Petition Number: 2023-042
General Location Identifier: 11907801

Transportation Summary

Rezoning Transportation Analysis Petition Number: 2023-042

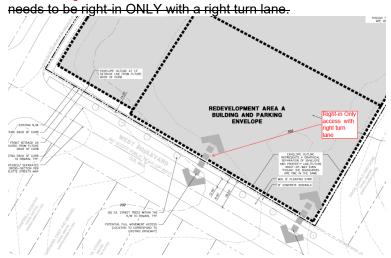
- Under future UDO guidelines this project would require a Comprehensive Transportation Review and mitigation. In leu of providing CTR, CDOT REQUESTS the petitioner provide APS pushbuttons and pedestrian ramp upgrades at the existing traffic signal at the intersection of West Boulevard and South Mint Street.
- 4. Outstanding Comment from 7.26.23: In coordination with NCDOT, revise site plan and conditional note(s) to commit to construct bicycle facilities by installing a 12' multi-use path on West Boulevard to meet the Council-adopted Charlotte BIKES Policy. Charlotte Streets Map calls for buffered bike lanes, NCDOT will not allow buffered bike lanes on West Boulevard. Multi-use paths maintained by the City shall meet ADA/PROWAG requirements.

Clarifying Comment from 11.27.23: Proposed streetscape is only 8'. Due to NCDOT not wanting a bike lane on their street, this needs to be a 12' shared use path.

Clarifying Comment from 12.21.23: Revise proposed streetscape to a 12' multi-use path to support council adopted Charlotte BIKES policy.

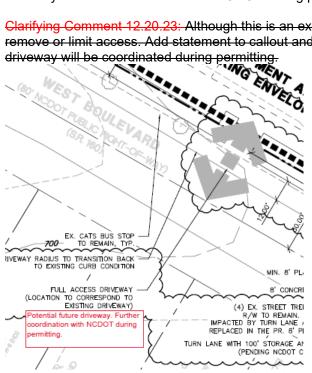
7. Outstanding Comment from 7.26.23: Per coordination with NCDOT, the site access on West Boulevard

Clarifying Comment 11.27.23: Revise site plane and conditional note to read, "Potential future driveway. Further coordination with NCDOT during permitting."

Clarifying Comment 12.20.23: Although this is an existing driveway, NCDOT has the authority to remove or limit access. Add statement to callout and conditional note that approval of West Boulevard

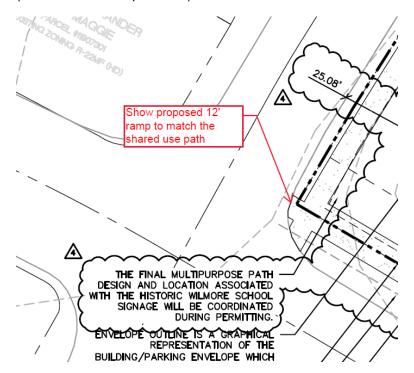
8. Outstanding Comment from 7.26.23: Per coordination with NCDOT, remove this site access along

9. New Comment 3.20.24: Show a proposed 12' ramp to match the shared use path width (ADA/PROWAG requirement).
